**PROJECT:** Strategic Housing Development

**REPORT:** Statement of Response to An Bord Pleanála's Notice of Pre-Application Consultation Opinion Ref.: ABP-312246-21

**CLIENTS:** Arnub Ltd. & Aspect Homes (ADC) Ltd

**DATE:** September 2022

Fig. 5 – Copy of Meath County Development Plan Land Use Zoning Map for Ashbourne

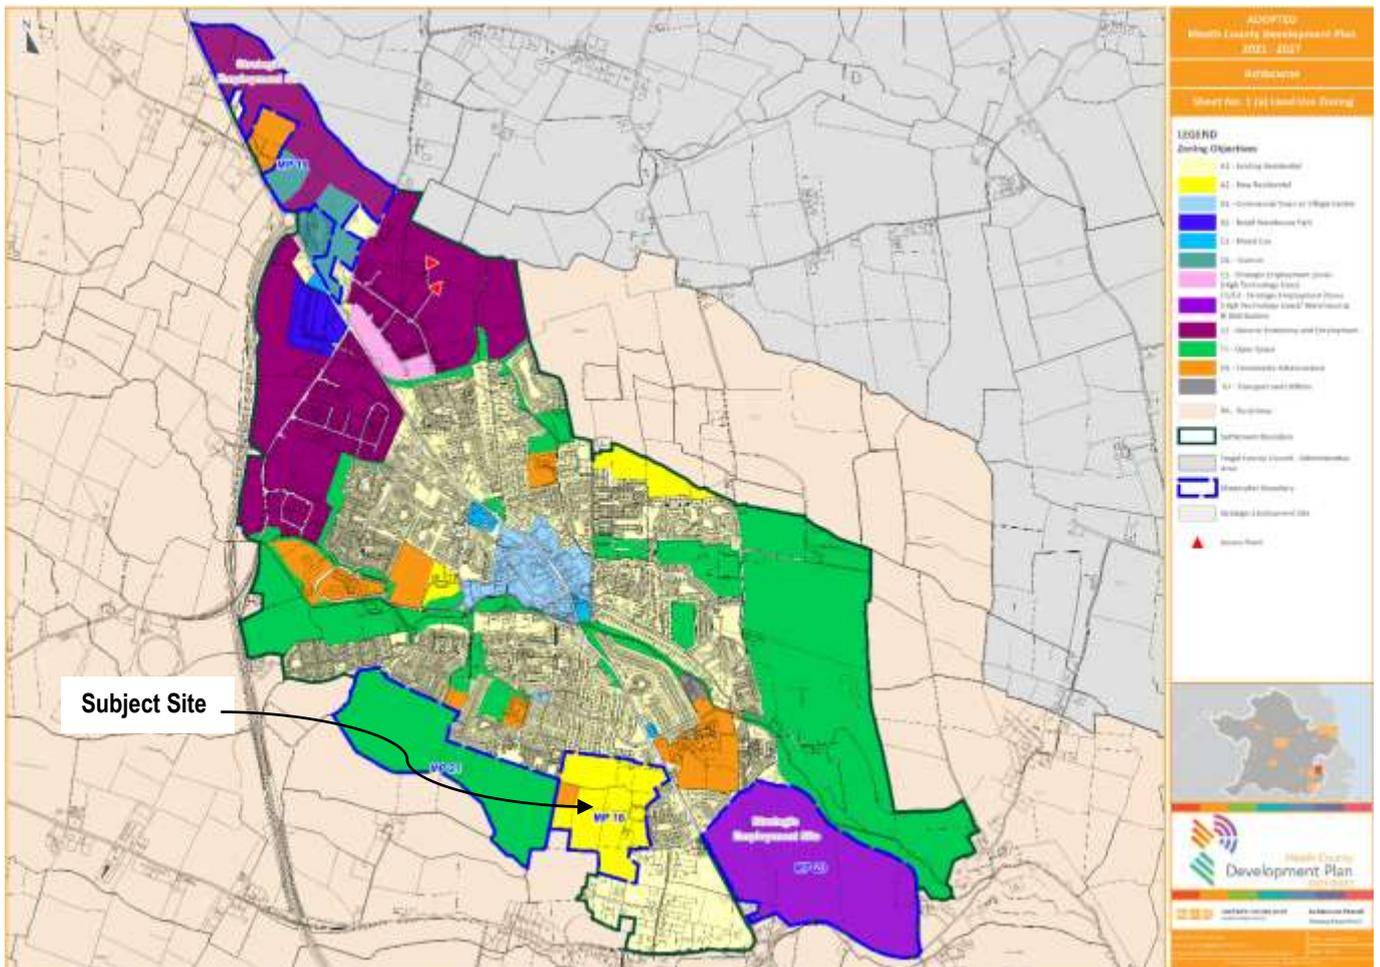
**Item no. 8** – In accordance with section 5(5)(b) of the Act of 2016, as amended, any application made on foot of this opinion should be accompanied by a statement that in the prospective applicant’s opinion the proposal is consistent with the relevant objectives of the development plan for the area. Such a statement should have regard to the development plan in place at the time of the application and that likely to be in place at the date of the decision of the Board in respect of the application.

**Response:** The Meath County Development Plan 2021-2027, was adopted on 22<sup>nd</sup> September 2021 and came into effect on 3<sup>rd</sup> November 2021. The Meath County Development Plan 2021-2027 (hereafter the CDP) is the current statutory Development Plan for the area, for the period 2021-2027. Volume 2 of the CDP sets out the Written Statement for Ashbourne, which includes a development strategy for the town and an approved land use zoning map (refer to Fig. 5 below). A “Statement of Consistency” demonstrating the proposed development’s compliance with the policies/objectives/development standards contained the CDP is submitted as part of this application for permission – please refer this standalone document.

We note that the Written Statement for Ashbourne contained in the current CDP states that “a detailed Local Area Plan for the town will be prepared during the life of this Plan” – this has not occurred to date. The previous Local Area Plan (LAP), Ashbourne LAP 2009-2015, has not been updated, but in consideration of the more up to date, statutorily adopted County Development Plan 2021-2027, which contains a written statement for Ashbourne, it is considered that the 2009-2015 Ashbourne LAP is no longer relevant and has been superseded by the current Development Plan and the Written Statement for Ashbourne contained in Volume 2 of the CDP - the submitted “Statement of Consistency” sets out the proposed development’s compliance with same.
